## Section 2.11 Water Resources

### 12-month Issues

**CENTRAL VALLEY ENERGY CENTER  
DATA ADEQUACY RESPONSES (01-AFC-22)**

**Figure 7.1-1a**  
**Groundwater Surface Elevations**  
**Spring 2000**

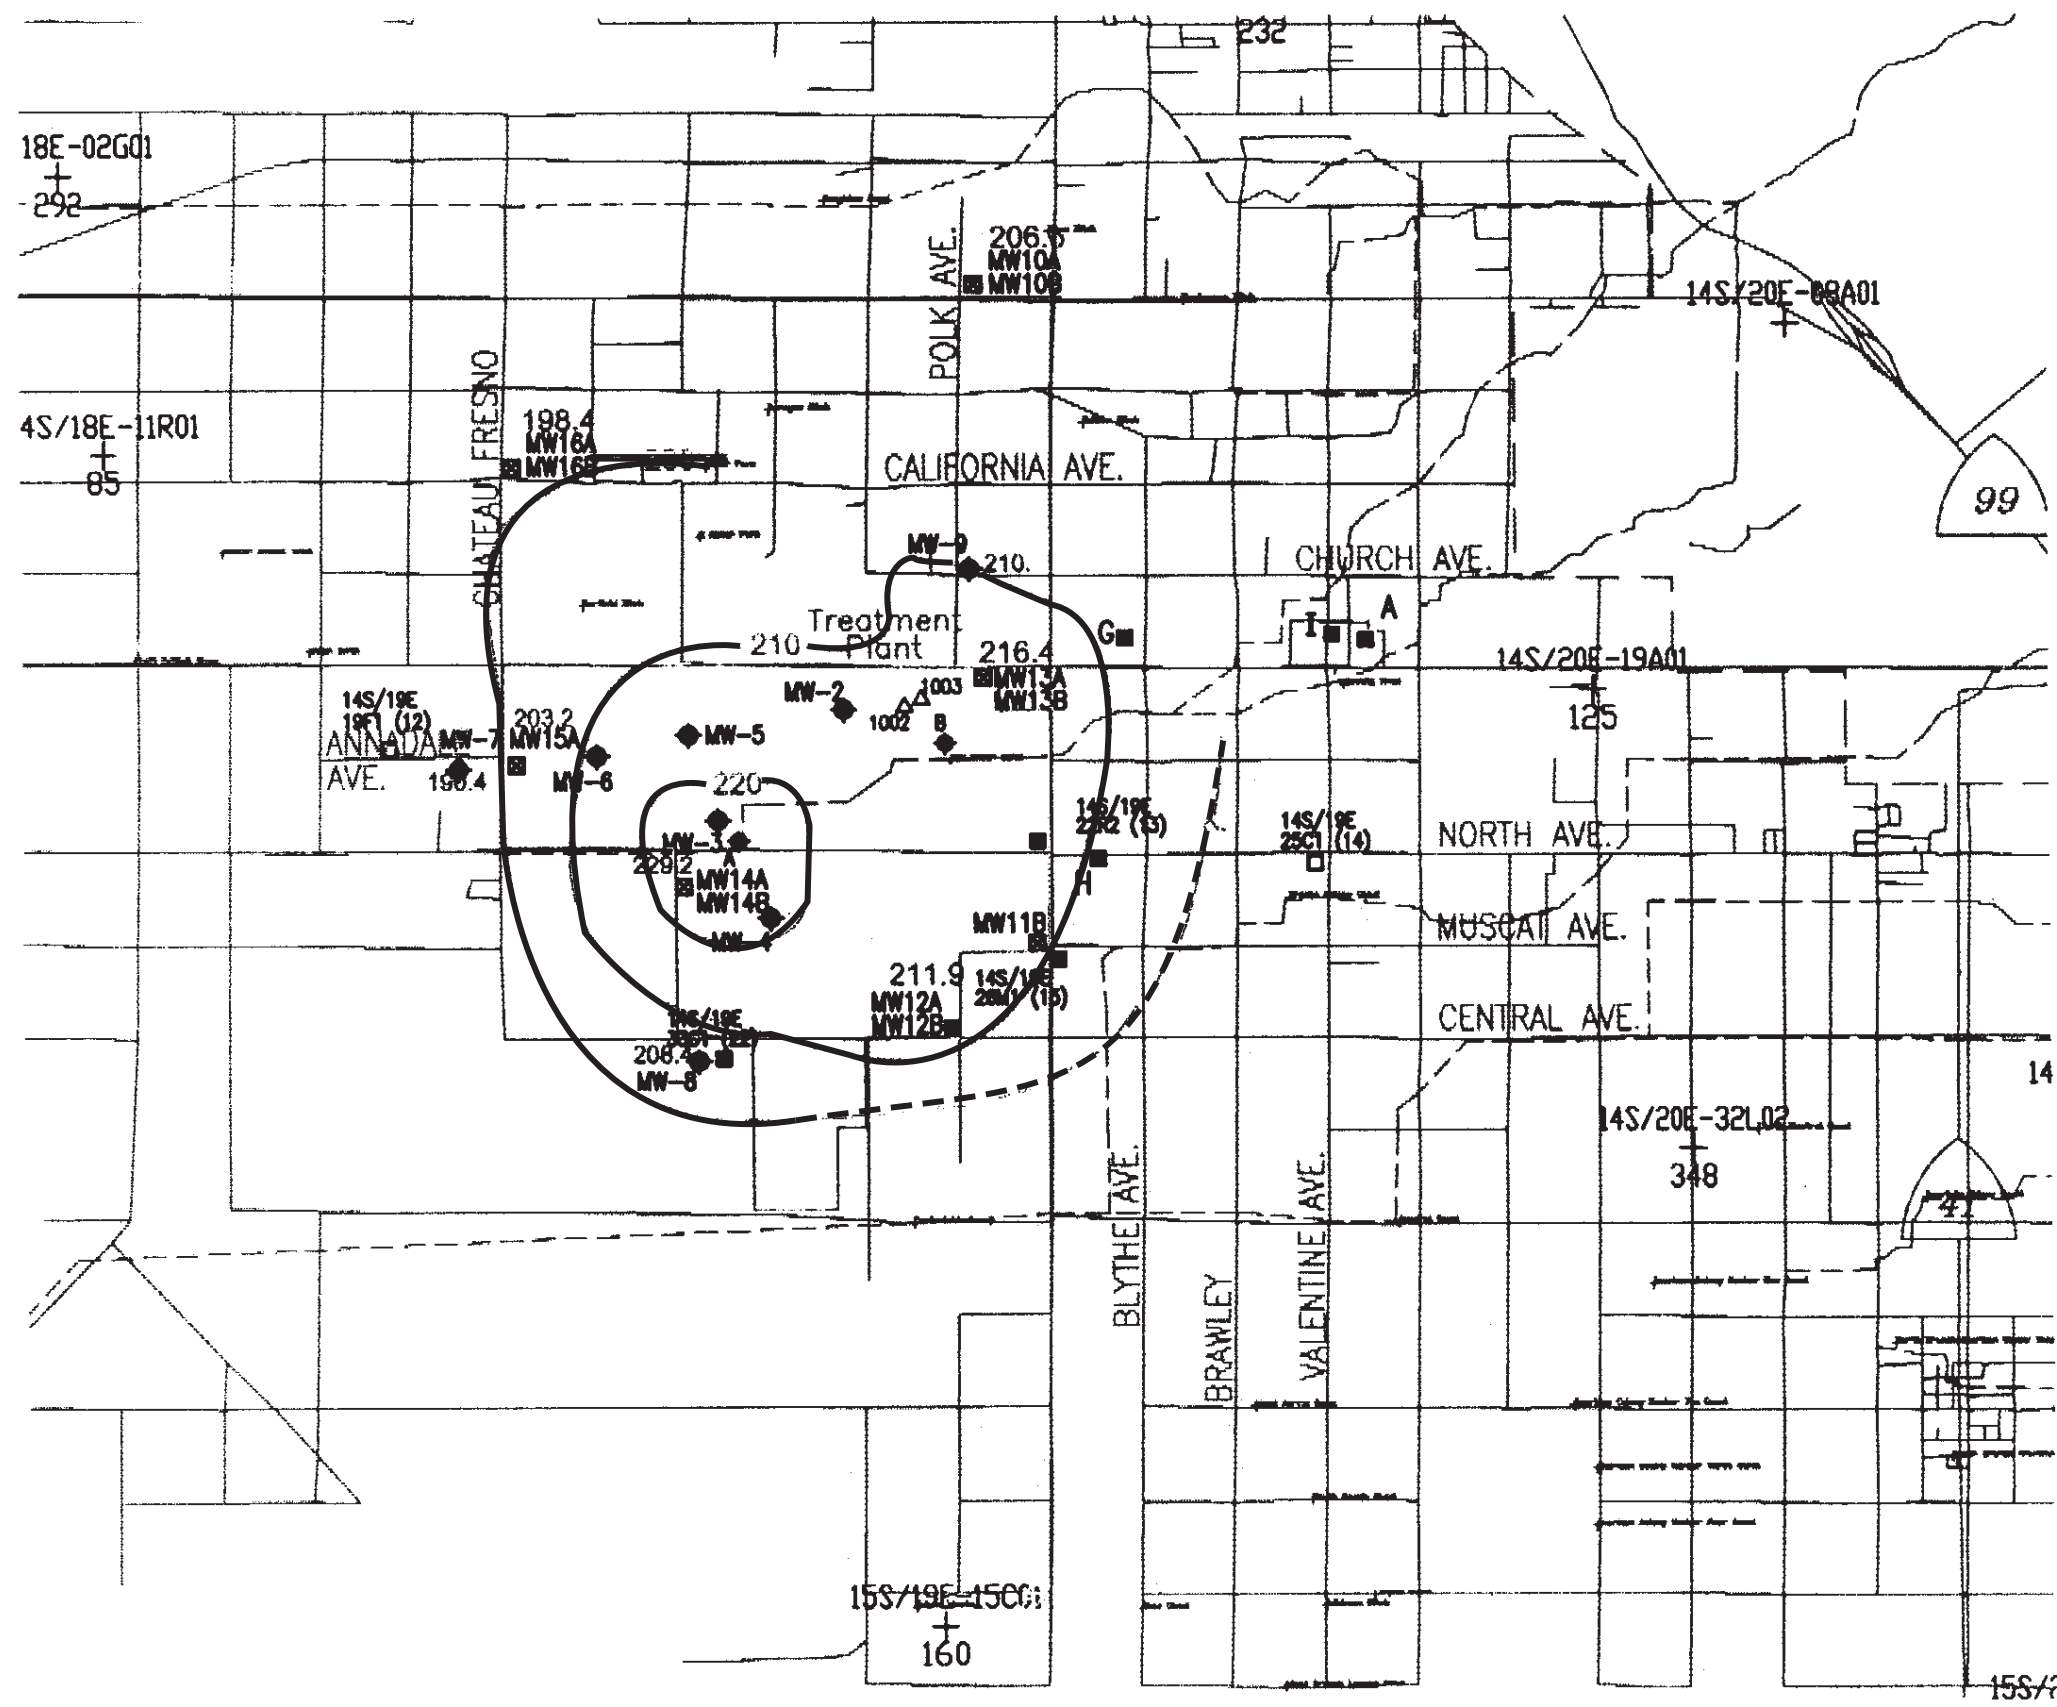
**12-WR-3 Data Adequacy Deficiency** – Provide a hydrostratigraphic map that depicts the areas affected by groundwater withdrawal for reclaimed water supply.

**Data Adequacy Response** – Cooling water supply for the CVEC will be obtained by extracting groundwater from the groundwater mound beneath the reclamation basins of the Fresno-Clovis Regional Wastewater Treatment Plant. The general direction of regional groundwater flow is towards the southwest (Figure 7.1-1a). Infiltration from the reclamation basins locally modifies the direction of regional groundwater flow, as seen on Figure 7.1-1a. Figure 7.1-1b presents a more localized evaluation of the groundwater mound beneath the reclamation basins. Figures 7.1-1a and 7.1-1b (attached) were both prepared with data collected during the Spring of 2000.

**FIGURE 8.14-4R**  
**CVEC PROPOSED**  
**DRAINAGE FACILITIES**  
CENTRAL VALLEY ENERGY CENTER  
APPLICATION FOR CERTIFICATION

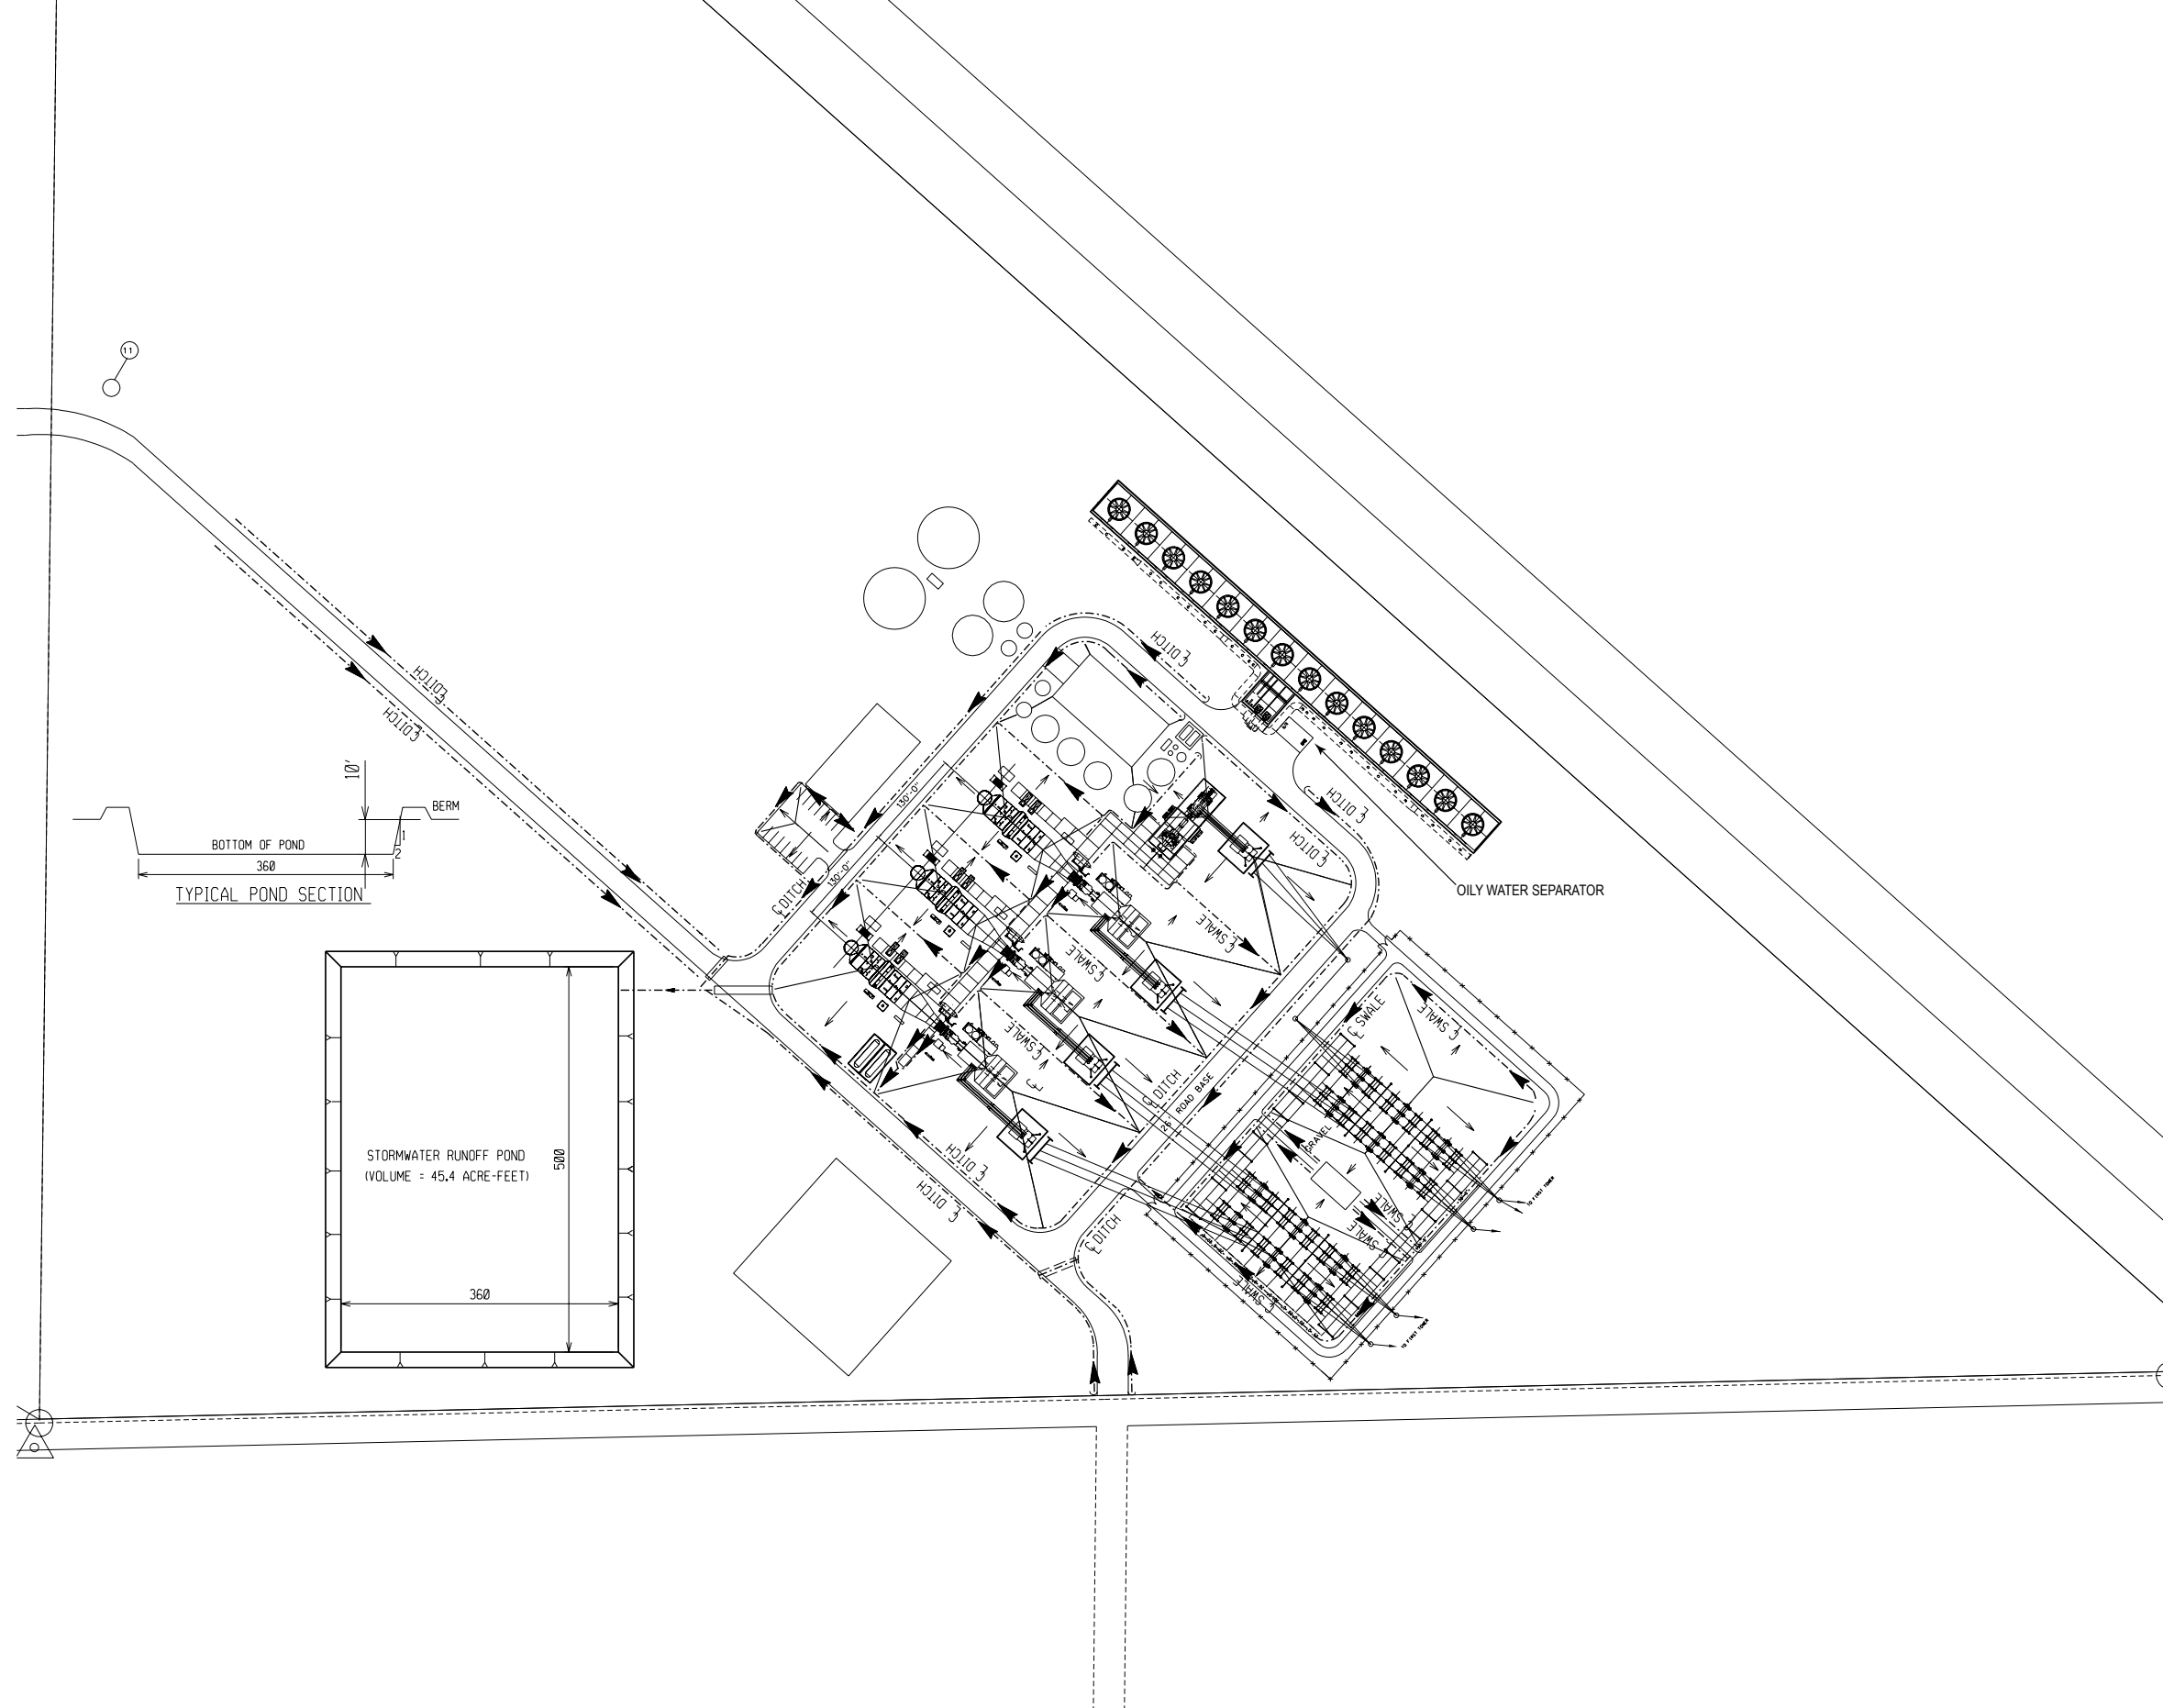
- 12-WR-4 Data Adequacy Deficiency** – Provide legible mapping (suggested scale less than 1"=100') that reflects existing and conceptual proposed contours for the proposed power plant site. This mapping should include legible contours for the proposed swales, ditches, and the detention basin.

**12-WR-11 Data Adequacy Deficiency** – Please provide complete and detailed drawings that exhibit all stormwater infrastructures associated with the proposed project (stormwater pipes/swales/ditch flow routes and discharge locations, inlets, oil/water separator locations).

**Data Adequacy Response** – A more detailed figure showing the conceptual contours, swales ditches and detention basin is attached here as Figure 8.14-4R.

**Data Adequacy Response** – A more detailed drawing showing the location of stormwater drainage, including oily water separators is attached to this response as Figure 8.14-4R.
